# UNITED STATES PATENT AND TRADEMARK OFFICE

APPLICATION NO.	FILING DATE	FIRST NAMED INVENTOR	ATTORNEY DOCKET NO.	CONFIRMATION NO.
10/671,820	09/26/2003	Michael C. Jones	DEP5086USA	6924
27777	7590	01/11/2008		
PHILIP S. JOHNSON JOHNSON & JOHNSON ONE JOHNSON & JOHNSON PLAZA NEW BRUNSWICK, NJ 08933-7003			EXAMINER SWIGER III, JAMES L	
			ART UNIT 3733	PAPER NUMBER
			MAIL DATE 01/11/2008	DELIVERY MODE PAPER

<b>Office Action Summary</b>	<b>Application No.</b> 10/671,820	<b>Applicant(s)</b> JONES, MICHAEL C. <span style="float: right;">CT</span>	
	<b>Examiner</b> James L. Swiger	<b>Art Unit</b> 3733

## **DETAILED ACTION**

Fig. 2

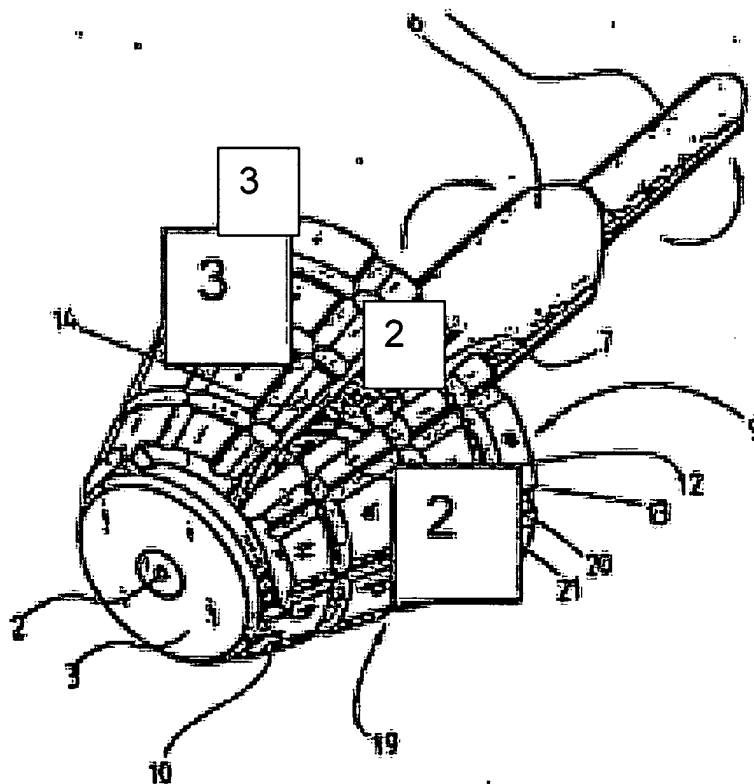
Parhofer et al. disclose a device having a first component defining a longitudinal axis (see Fig. 3, item 1), and a second component (19) movably associated with the first component (see joint at 10) in a radial direction (Fig. 2) and are separable by the an opening. The device further has a body (Fig. 3), and a stem extending from said body (6), and wherein the second component is tapered (Fig. 1). The device also has a restraining portion (8) and a cooperating portion of the second component (10) to provide restrained motion. The device also has a third component moveably associated with the first component (See Fig. 2 below, and the section denoted as "3" is the third component).

Further, the internal side of component 2 has a surface associated with the first component (on the inside) while the second component has a surface capable of contact with bone material and that is also capable of urging the particles radially (see Col. 2 through Col. 3). The device also provides for a motion of the second component away from the longitudinal axis of the first component as the first component is advanced axially (Col. 5, lines 41-63).

Parhofer et al. disclose the claimed invention except for a groove and protrusion that helps to regulate the actuation between the moveable components. Termanini teaches an instrument that is capable of compressing bone with components that interact with a groove (3) and protrusion (8) see Figs. 3 and 4. They are considered to have sliding movement with respect to one another. It would be an obvious modification to have multiple components as taught by Parhofer et al. See also Col. 3. It would have been obvious to one having ordinary skill in the art at the time the invention was made to construct the device of Parhofer et al. having at least the grooves and protrusion in view of Termanini to have improved actuation when compacting bone.
